Brothers Corporation

**DEPARTMENT OF
PLANNING & ZONING****Exhibit 3**

Re: Project Narrative for Garden Street Apartments (formerly Grove Street Apartments).

Date: February 17, 2015

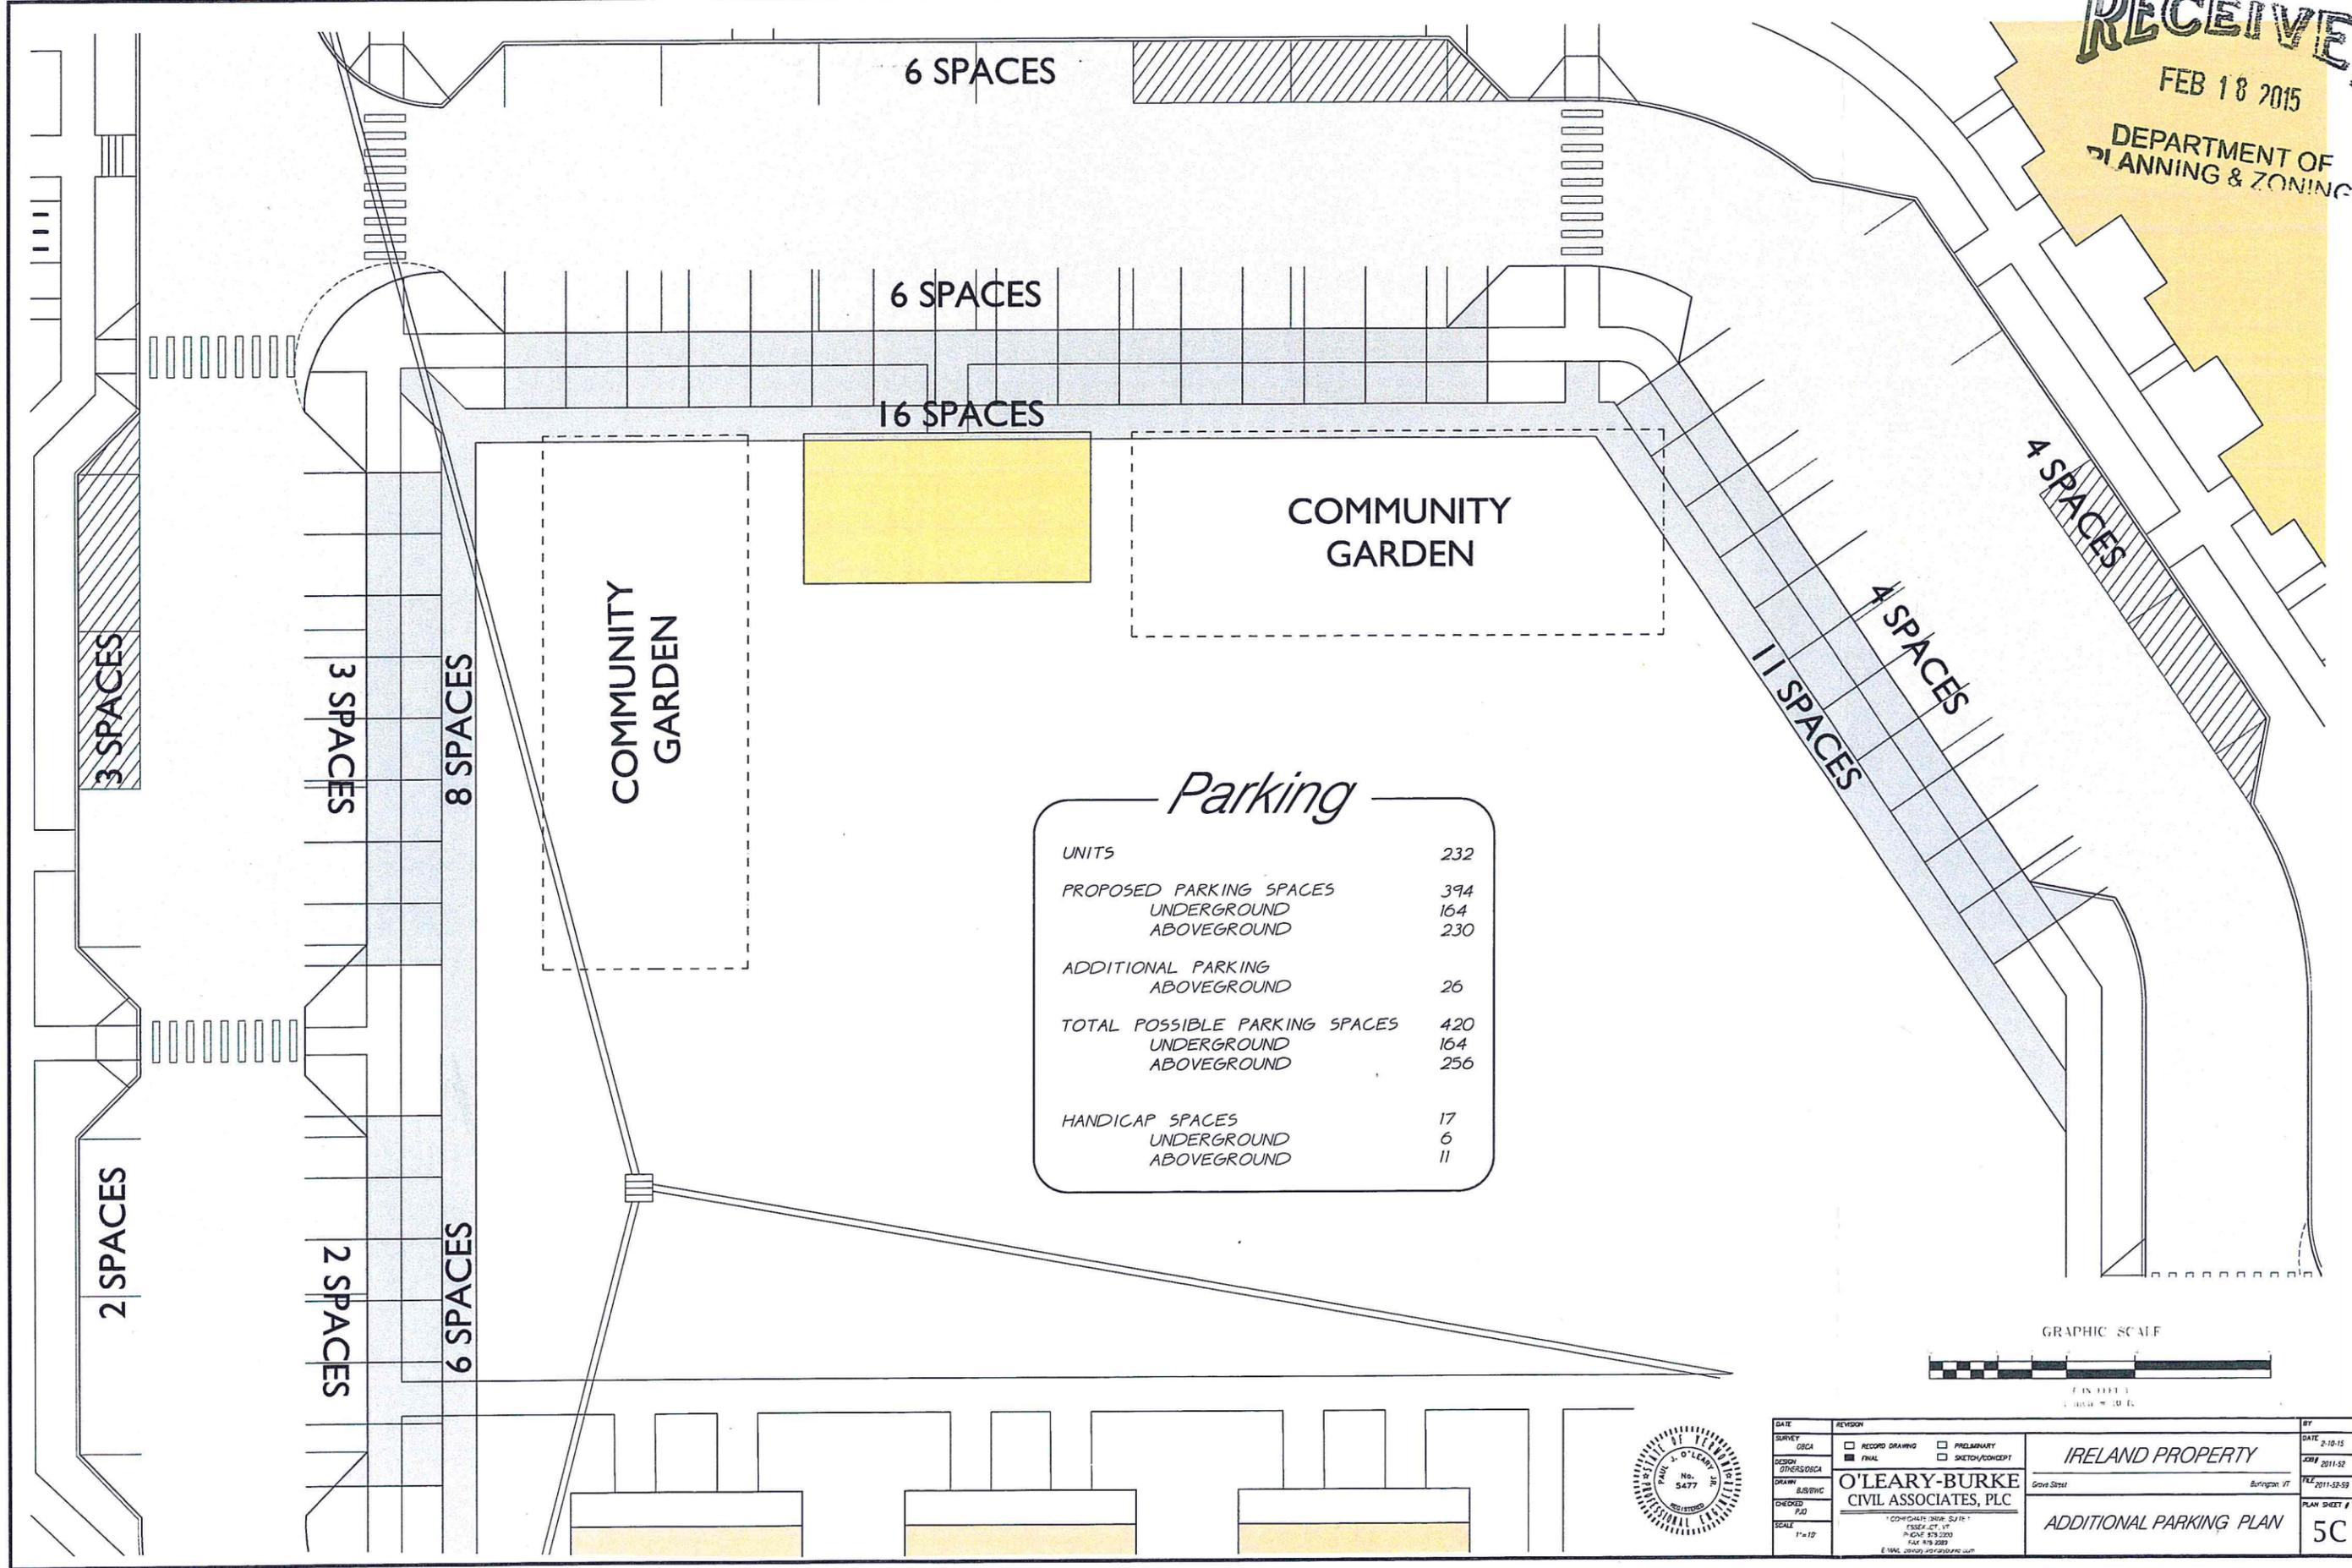
(VI) CONTINGENCY PLAN: In the event that additional parking is necessary there is ample room to add additional parking by adding pavement to the perimeter of the green around Garden Street. See attachment plan. This would be done by adding 9' of pavement around the perimeter and rotating the spaces 90 degrees to make them standard perpendicular parking spaces. This would add a total of 26 spaces. In the event that the board feels that this change should take place now, we would be happy to make the change as a condition of approval. We would rather build the parking this way but acknowledge that at Preliminary we proposed all of the "on-street" parking as perpendicular and the general consensus of staff and the board was that took away from the interior streetscape.

The increase in parking will add 4,655 SF of impervious coverage to the site. This will not have an effect on the stormwater design as we over designed the system with an additional 10,000 SF of impervious coverage that is not currently being built. The lot coverage for the site will increase from 42.8% to 43.3% (net increase of 0.5%). We would have to move the existing pavilion and gardens back a couple of feet, away from the street in order to fit the 5' sidewalk.

CROSS SECTION FOR A "FORM LINED" WALL.

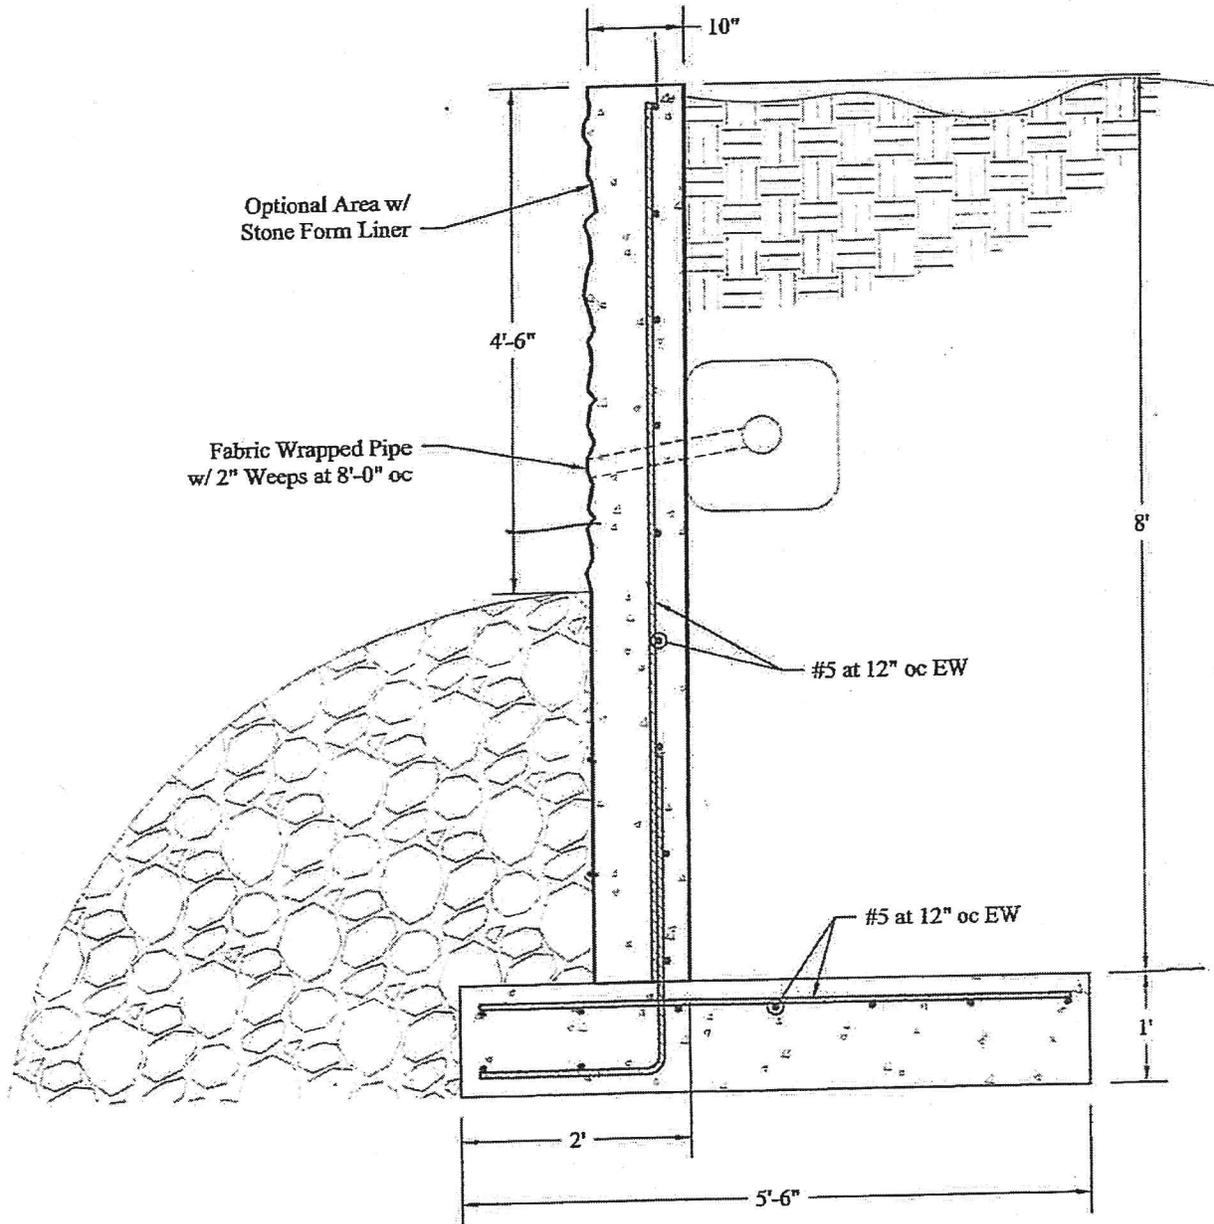
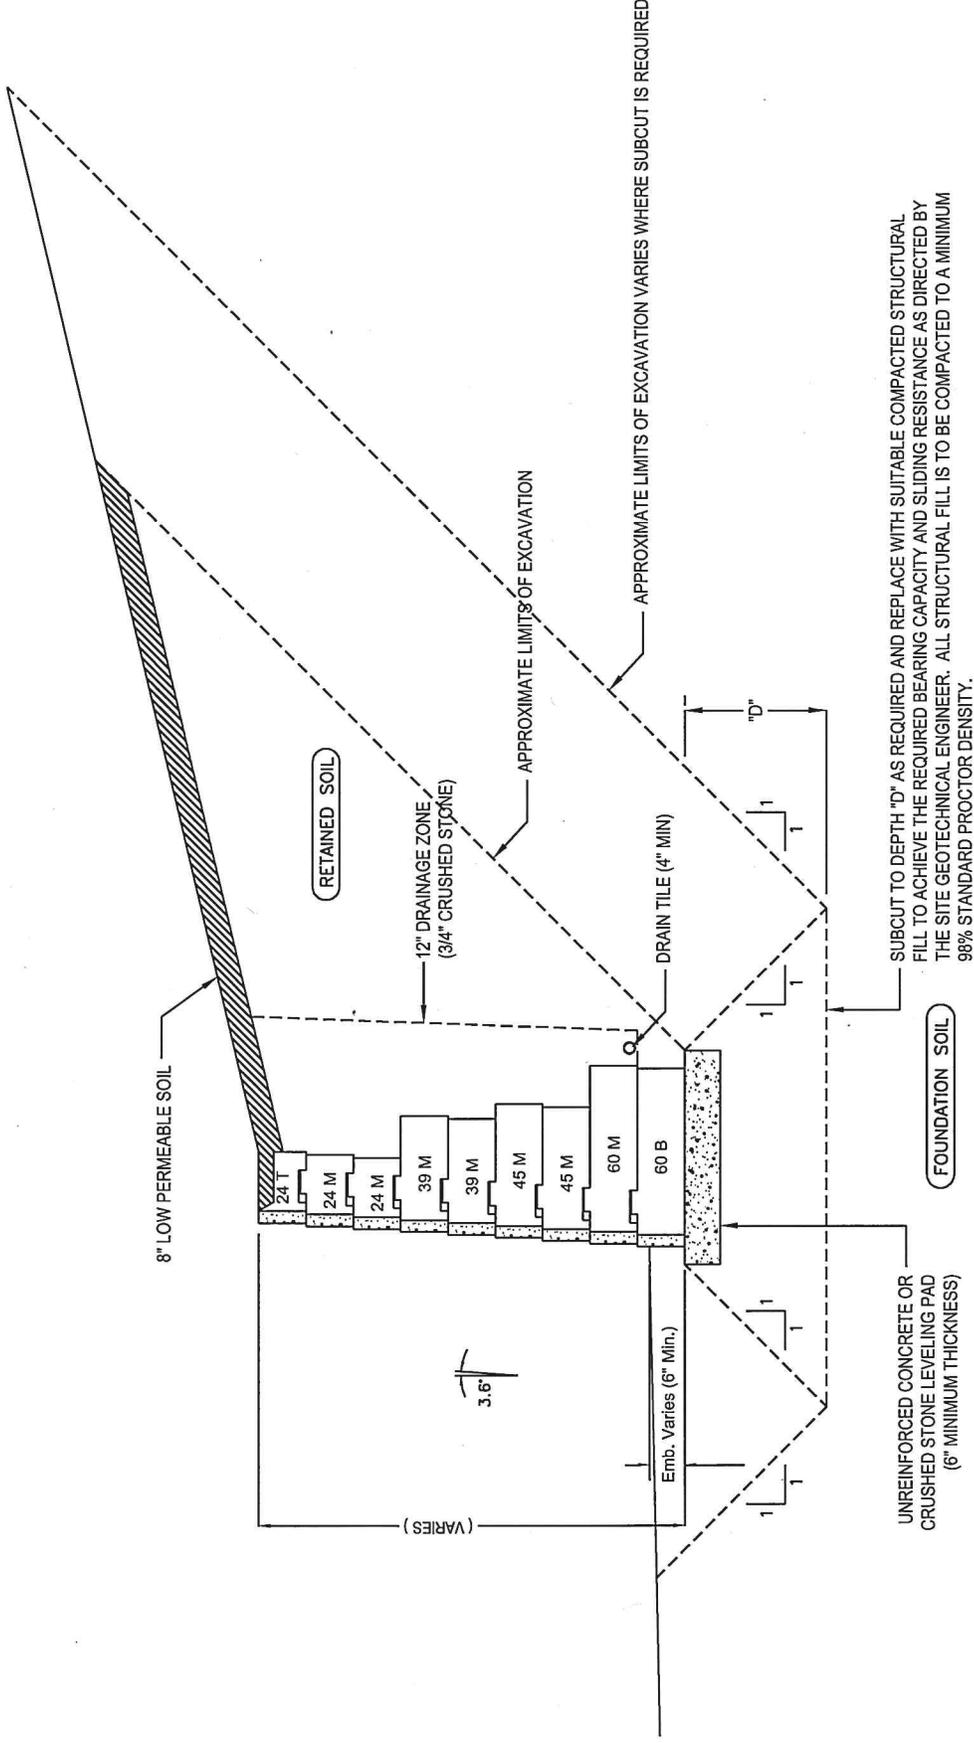
- B) We have two types of retaining walls, we are calling them Gravity and Form Lined and we refer to them on the last sheet of the package, A-11. Spec # 5 is the form lined wall. Form liners are the liners used in the preparation of designs on concrete walls. The use of form liners often results in more attractive poured concrete walls. Form liners come in many different shapes and designs, and can produce a variety of different results on concrete. A form liner panel is placed on the inside of a concrete forming system before the concrete has been poured and acts as a mold for the concrete to be formed against. Once the concrete has set, the forming system can be removed and the form liner can be stripped from the hardened concrete surface. The resulting concrete surface is permanently textured with the pattern of the form liner.

- The form liners are attached to forms and concrete is placed against the liner. The liner pattern is transferred into the wet concrete. After the concrete has cured, the liner is stripped and the unique sculpture is exposed. This wall has a standard poured footing and wall and the interior of the form is lined with a stone wall pattern and the concrete is can be dyed to match the color you want. If you refer to the illustrations that look down Arbor Street to the lower level, this is a good depiction of the color and pattern we propose. Attached is a cross section of what that wall looks like. The second type of wall is depicted as Spec #6, and is basically a pre-cast boulder concrete retaining wall system. They are typical referred to as Recon Block wall Systems. In regards to
